Comment Letter I99

**SOITEC SOLAR DEVELOPMENT
PROGRAM ENVIRONMENTAL IMPACT REPORT**

3800 12-010 (GPA); Tierra Del Sol, 3300 12-010 (MUP), 3600 12-005 (REZ),
3921 77-046-01 (AP); Rugged Solar, 3300 12-007 (MUP);
ENVIRONMENTAL LOG NO.: 3910 120005 (ER)

Response to Comment Letter I99

3.1.5

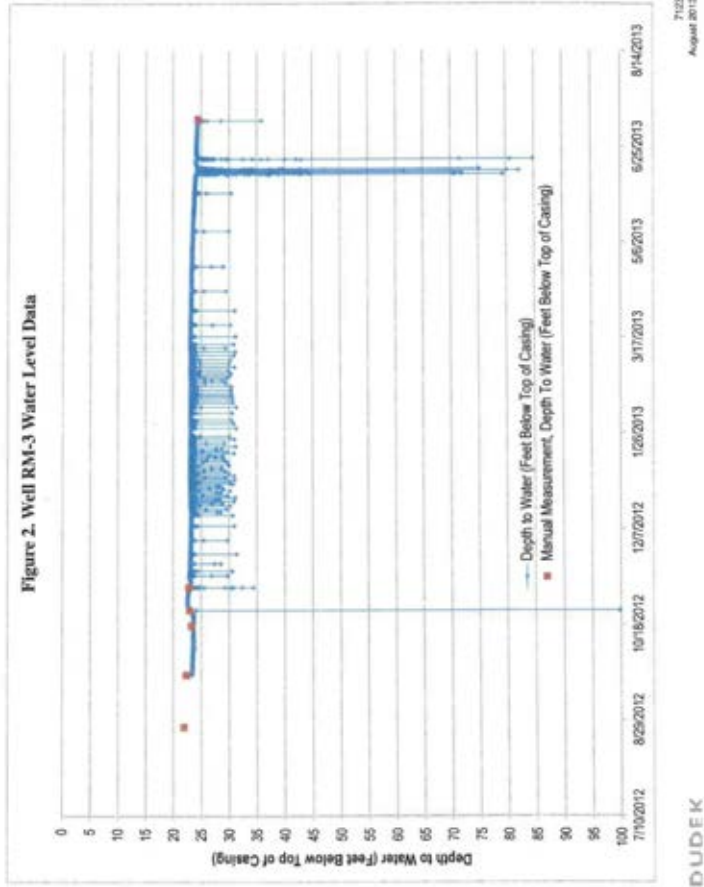
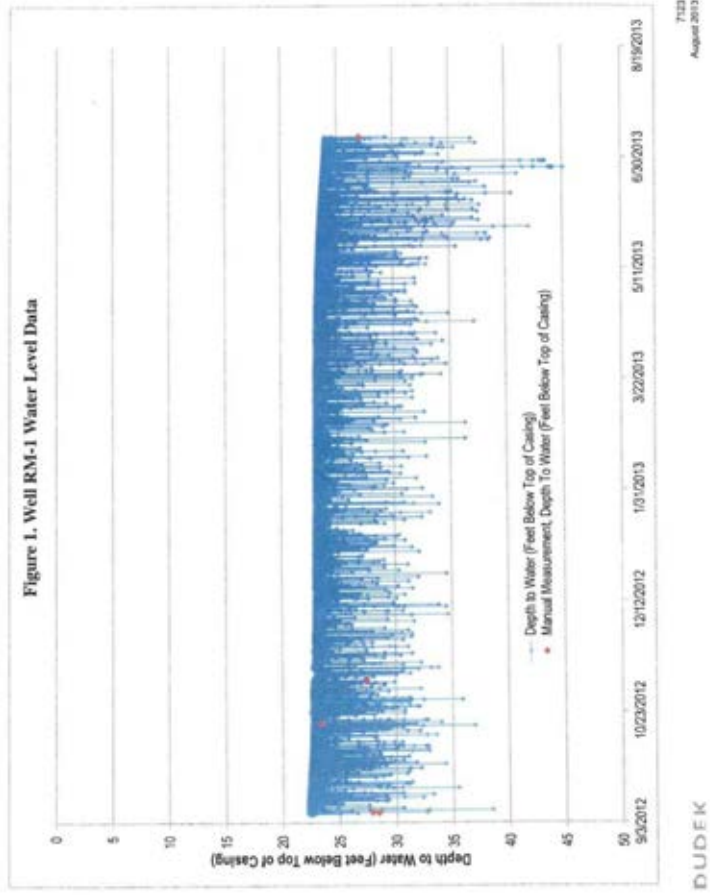
In the E I R (3.1.5), copy included with well water level data from Dudec, it looks like they did the 72 hour draw down test in June. RM-2, my well in the pasture, dropped from about 25 feet below the top of the casing to 85 feet. Or a drop of approximately 60 feet. RM-1 is the well that supplies my house. It dropped from approximately 24 feet from the top of the casing to 45 feet below. A drop of 21 feet. The test well B was to be the 72 hour test according to the Dudec people. We have no grass in our yard to water and few plants, due to the water shortage in the area. The E I R written by Dudec for the Soitec solar project is so misleading it is on the verge of being criminal. Dudec did a ground water survey for a project in Poway stating that the ground water to be used by the project would in no way have an effect on the surrounding users. On the strength of that, the project was approved. A ground water survey done at the same time by Victor M. Ponce stated that, if the project went forward, the local ground water would be severely affected. It was ignored, probably due to lobbying, although I can't prove it. Within 60 days the water in the surrounding wells dropped drastically. I am including the ground water study done by Mr. Ponce for the Boulevard and surrounding communities.

increased duration of the pumping and higher demand for water during the summer months. The commenter is referred to Mitigation Measure M-BI-PP-15 (DPEIR Chapter 2.3), which describes the Groundwater Mitigation Monitoring Plan to be implemented as part of the Proposed Project. The commenter's wells RM-1 and RM-3 will be part of the monitoring network.
